Sheringham Shoal and Dudgeon Offshore Wind Farm Extension Projects

Apportioning and Habitats Regulations Assessment
Updates Technical Note (Revision D) (Tracked)

Deadline 7

Document Reference: 13.3.1

Title:
Figure 3 Potential exclusion areas from SEP to avoid impacts to Greater Wash SPA Red-throated Diver populations

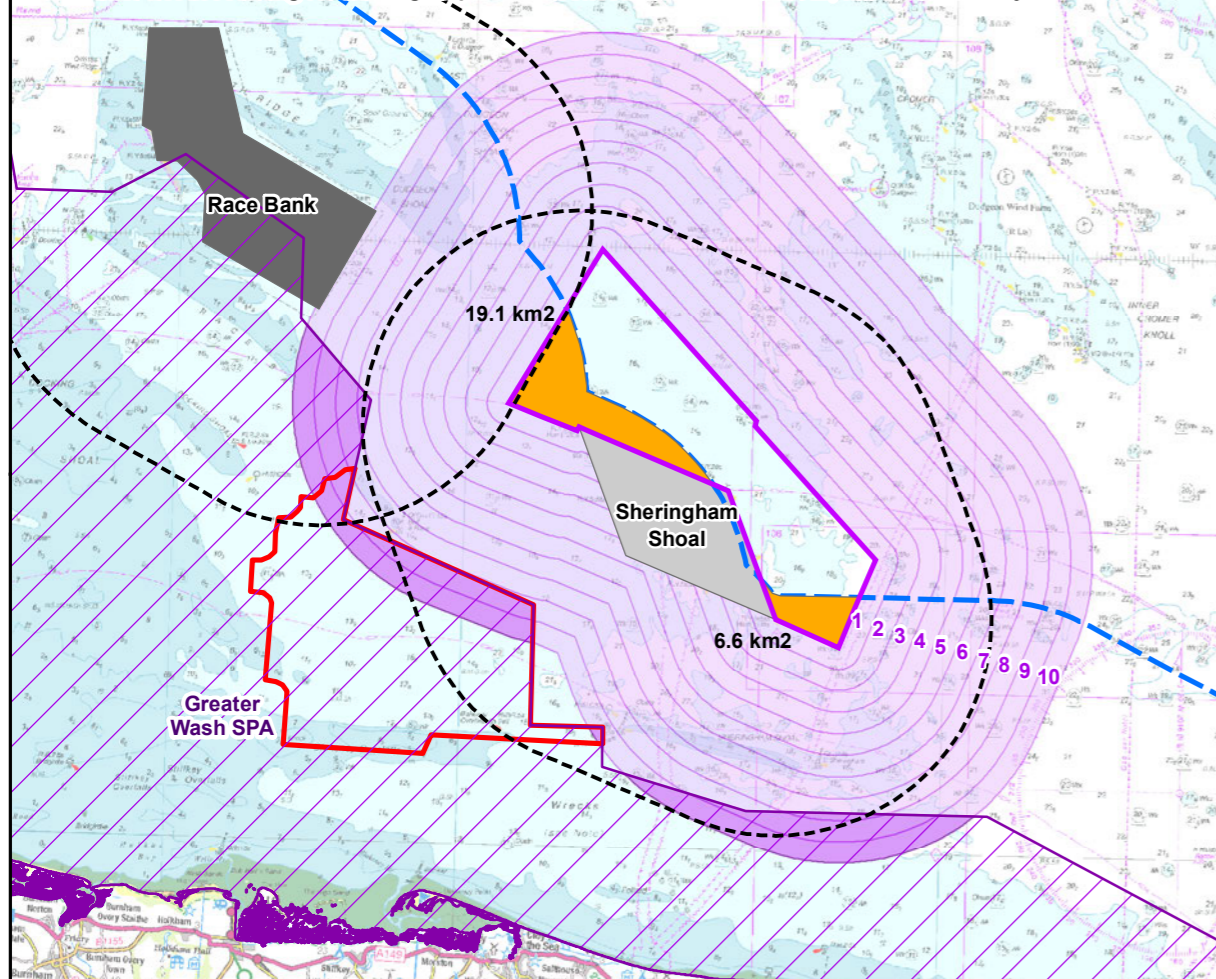
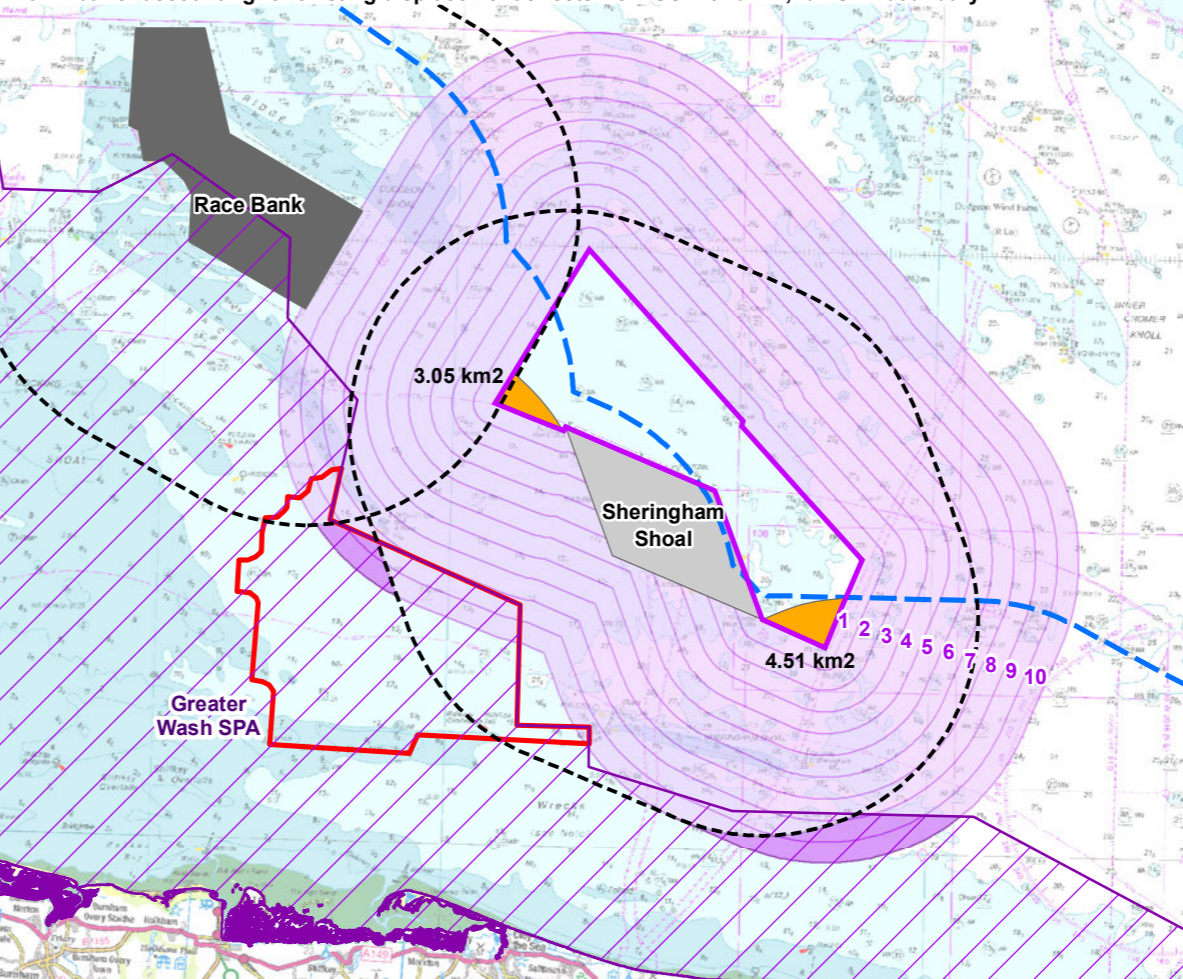
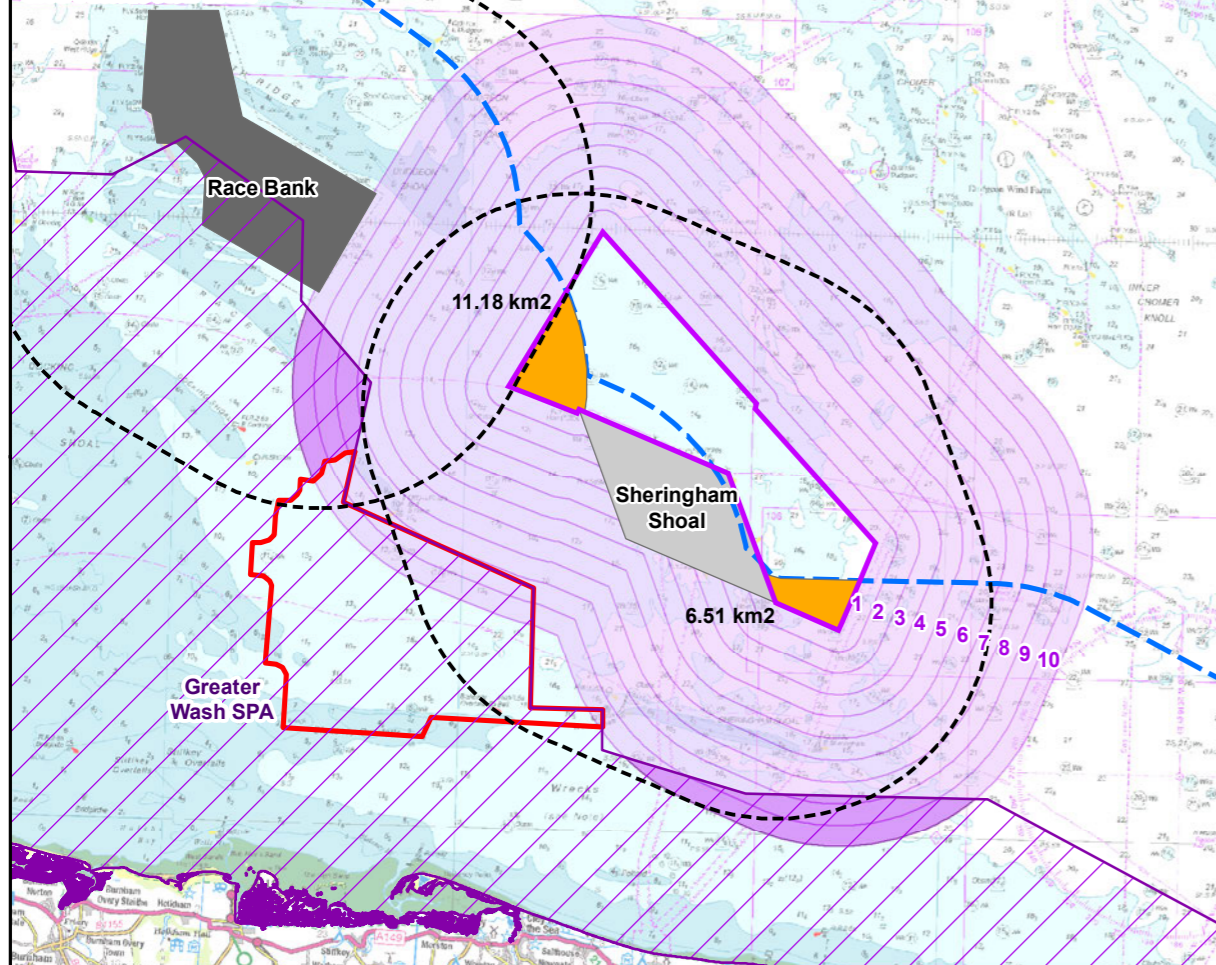
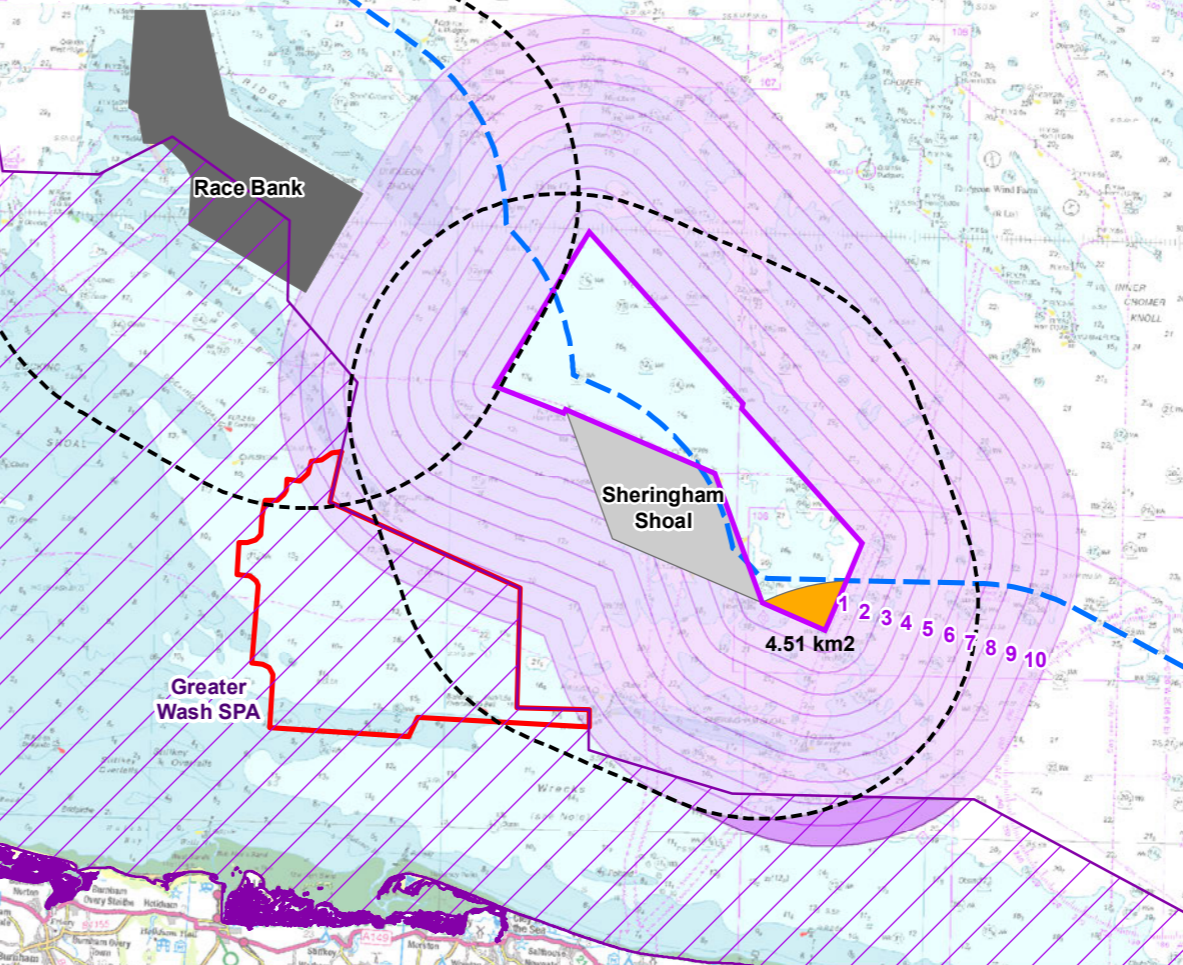
23	11. GW SPA RTD		<p>NE have some concerns over the validity of the method used to calculate the 'effective area' of displacement by scaling the area of effect proportionally according to the corresponding rate of displacement. This is because the proportion of the population that is displaced is not analogous to the area that birds are subject to displacement from. The logical supposition, if the area of effective displacement is say 55%, is that all of the divers remaining are using 45% of the area. However, this is not how displacement of Red throated diver is likely to operate, as the birds that are not displaced from a given area could well utilise it all. So, the area of effective displacement is always 100% for the birds that are displaced and could be 0% for the birds that are not displaced. In this case there seems no logical way to proportionally reduce the effective habitat loss. However, we do recognise the potential value in trying to account for the gradient of effect in spatial terms but in light of the relevant conservation objectives, consider that an area subject to any displacement effect is to</p>	<p>Noted. The Applicant maintains that it is reasonable to use the displacement gradient as a proxy to understand the 'effective area' of displacement. If this approach is not applied (or in the absence of an alternative approach proposed by Natural England), this suggests that the effect is the same, irrespective of the distance from the wind farm. This is not logical and will result in an unrealistic and wholly over-precautionary outcome. However, as Natural England notes, the presented information includes both the total area and effective area calculations.</p>

119. The four approaches are shown on **Figure 3**, which all result in a reduction of the total area of GW SPA impacted; the areas where an effect would be avoided are shown shaded dark pink on **Figure 3**. For Approach 1, the impacted area is reduced to zero, but for other approaches the impacted area is reduced from 1.77% (i.e. that calculated using the full SEP wind farm site boundary) to between 0.69% (Approach 3) and 1.36% (Approach 4); the effective area of displacement would be reduced from 0.56% to between 0.23% (Approach 3) and 0.44% (Approach 4).

121. As noted in **Section 1**, notwithstanding its conclusions that an AEol on the red-throated diver feature of the GW SPA can be ruled out, the Applicant has committed to implementing Approach 4. This would remove all remaining potential effects on GW SPA red-throated diver populations due to the presence of wind turbines at SEP, when the effects of existing OWFs and the MCA boundary are taken into account.

Title:
Figure 4 O&M vessel routing along existing SOW/DOW routes

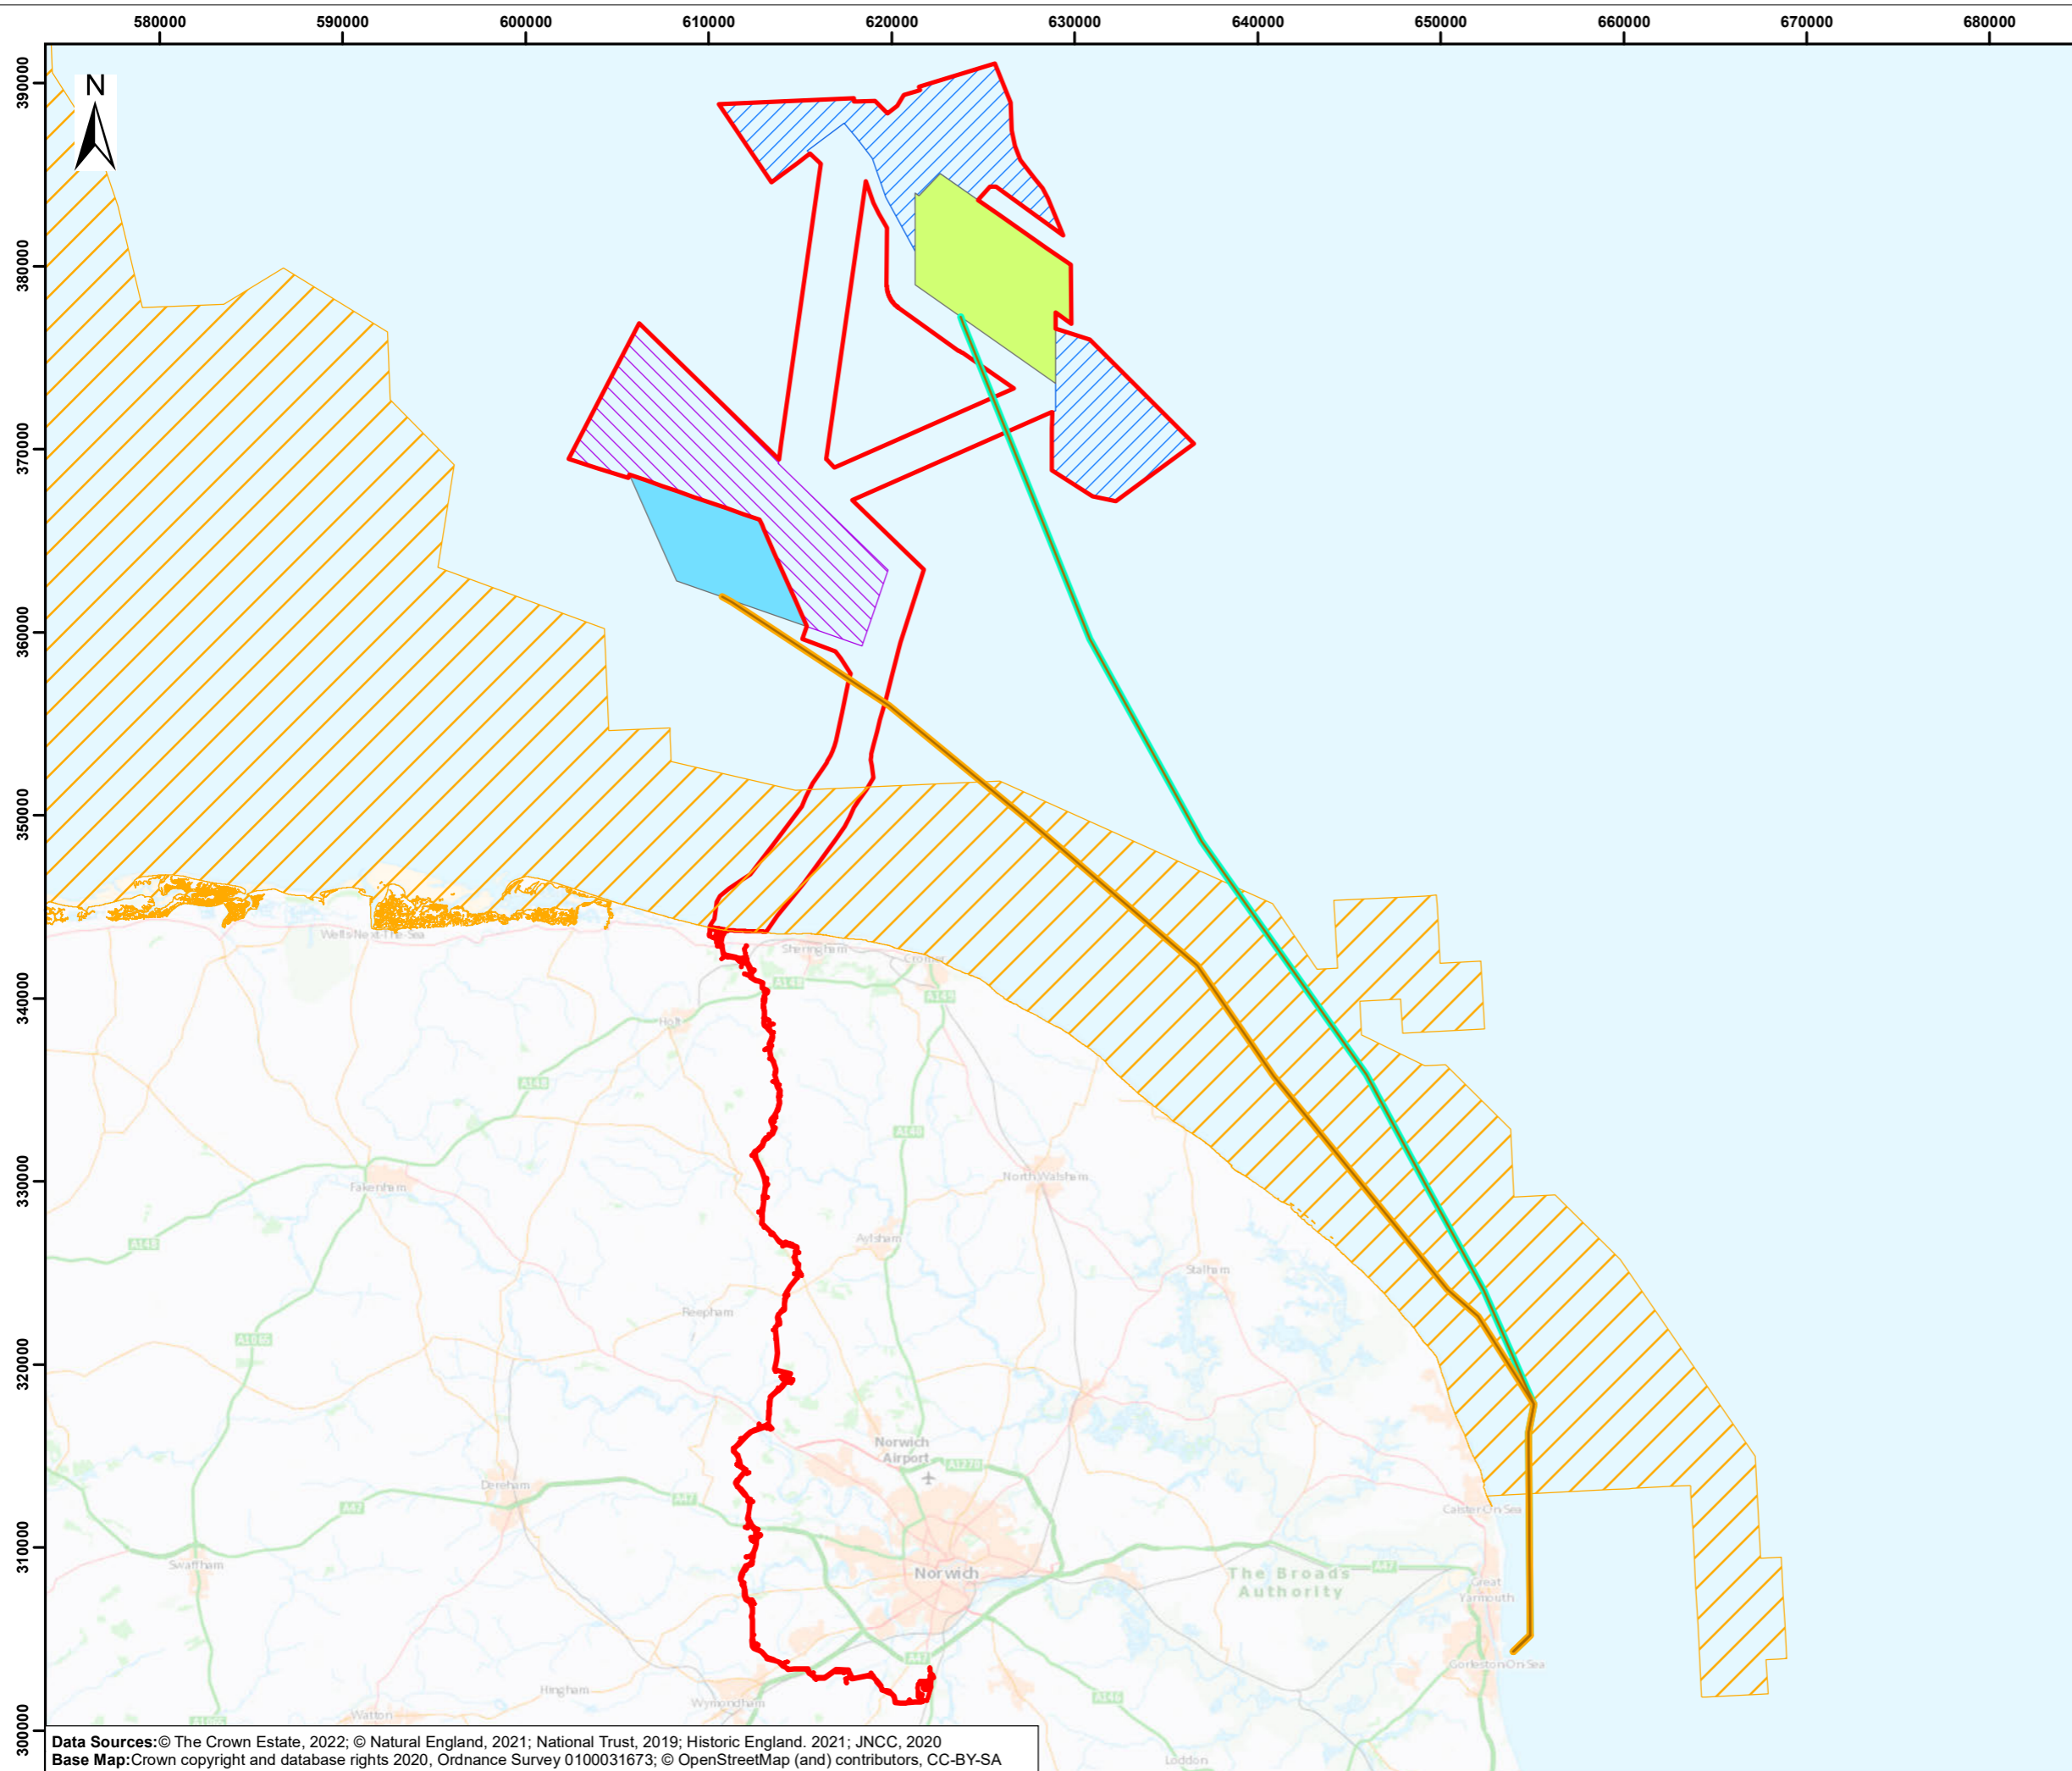
ID	Section of draft document	Paragraph	Natural England comment	Applicant response
			to quantitatively assess the potential in-combination impact of operational vessels on Greater Wash SPA red-throated diver'. Natural England believes that there is additional data available on the impacts resulting from vessel activity associated with relevant existing OWFs, both in terms of mortality and the area subject to displacement, which would enable the applicant to undertake a more quantitative assessment for the Greater Wash SPA and would be happy to discuss this further.	
21	11. GW SPA RTD	96-97	NE welcomes the consideration of the reduction in available habitat as a result of cable installation vessels to the assessment. However, we feel there is not enough information provided to determine whether the Applicant's suggested worst-case scenario (concurrent construction of the SADEP export cables) can be considered as such.	Paragraph 111 states, 'Assuming that levels of activity are equal across the length of the cables, the total duration of activity affecting the SPA (assuming a worst case of 110 days, where SEP and DEP cables were installed separately) would be approximately 25 days.' In other words, the Applicant has assumed that the <u>sequential</u> (and not concurrent) approach represents the worst-case scenario in respect of red-throated diver. This is because the total duration of work is longer for the sequential scenario and that the displacement effect at any one location would be short-term, i.e. birds would return to affected area soon (within a few hours) after vessel departure.

123. The Applicant is already committed to restricting vessel movements to existing navigation routes (where the densities of red-throated divers are typically relatively low) (see the **Outline PEMP (Revision D)** [document reference 9.10]. By using existing transit routes (i.e. those used by O&M vessels for SOW and DOW) (**Figure 4**), it is considered that this would reduce any additional effects from SEP and DEP vessels to a negligible level. This is because the total area at risk of disturbance along the vessel corridors would be unchanged from the existing situation. Use of the O&M vessels would be shared with SOW and DOW, and existing vessels would maintain the same frequency of transits, as follows:

124. In both options, the number of SOV transits to port would be unchanged from the existing situation (i.e. from existing SOW and DOW traffic). In the case of Option 2, there would be no change to the overall number of vessel transits through the SPA, i.e. there would still be 1 CTV as well as the SOV. In the case of Option 1, the number of SOV transits would be unchanged, but there would be a small increase in the number of CTV transits which would not materially increase overall vessel activity (wind farm and non-wind farm) relative to baseline.
